SB-GA8-2012-81

Issue 3

Service Bulletin

Modifications required for aircraft to be registered in Malaysia

Figure 1 : “Amber” ALT indicator

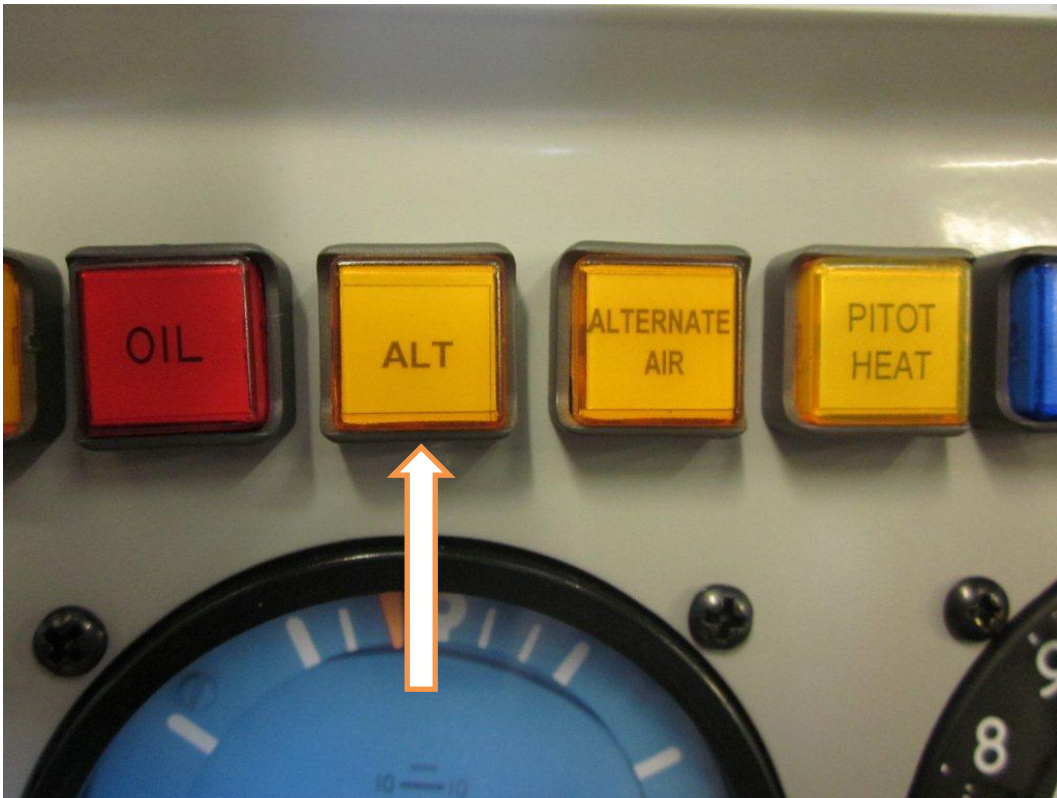
1. So as to comply with Department of Civil Aviation Malaysia Airworthiness Notice No 72 Issue 2, the existing amber ALT lens is to be changed to red. This modification may be performed with the flight instrument panel in situ.

2. The aircraft Bus 1 and Bus 2 Master switches located in the overhead electrical panel are to be turned off.
3. The ALT annunciator is shown in Figure 1 as fitted to a typical flight instrument panel. Carefully remove the amber housing. Discard the amber housing.

4. Take note of the keying used within the lamp housing. Refer to Figure 2. When assembling the red lens, white diffuser and placard, ensure that the keying of the diffuser and housing match. Refer to Figures 3 and 4.

Figure 3 : Disassembled diffuser, placard and lens cover.

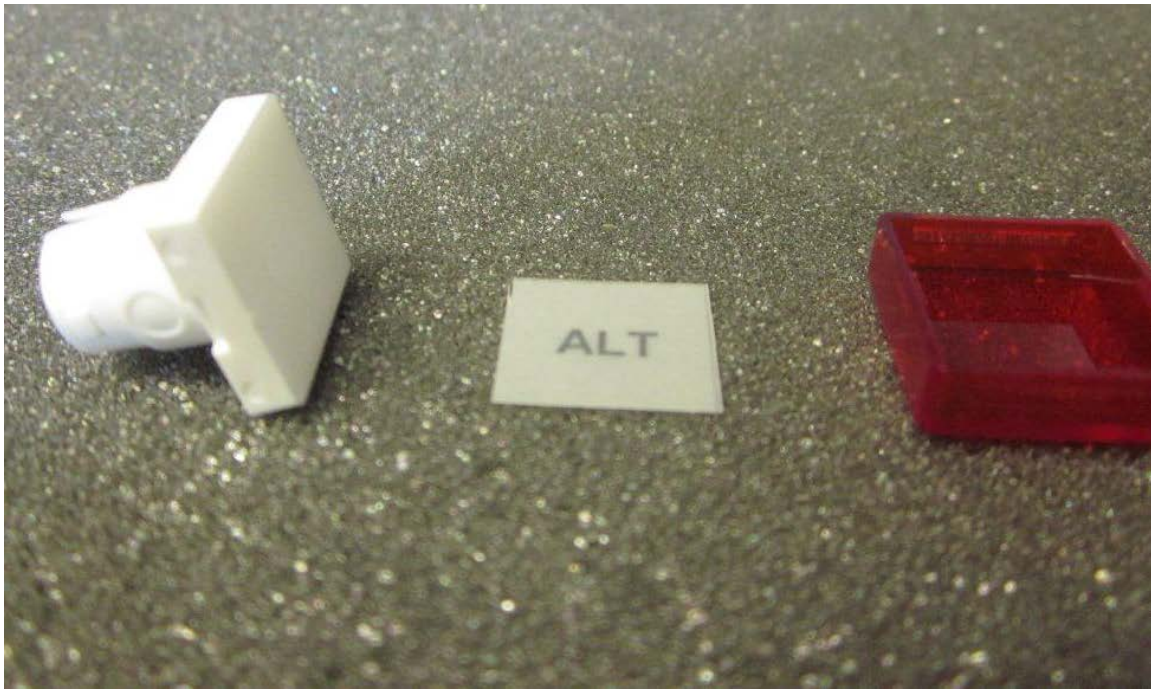
5. Fit the red ALT lamp cover (item 1) as shown in Figure 5.
6. Apply power to the aircraft by switching on Bus 1 and Bus 2 Masters.
7. Undertake a lamp test from the flight instrument panel. The push-button test lamp is located on the top right hand side of this panel. The red ALT lamp should be illuminated when operating from the aircraft battery. Switch off Bus 1 and Bus 2 Master switches.
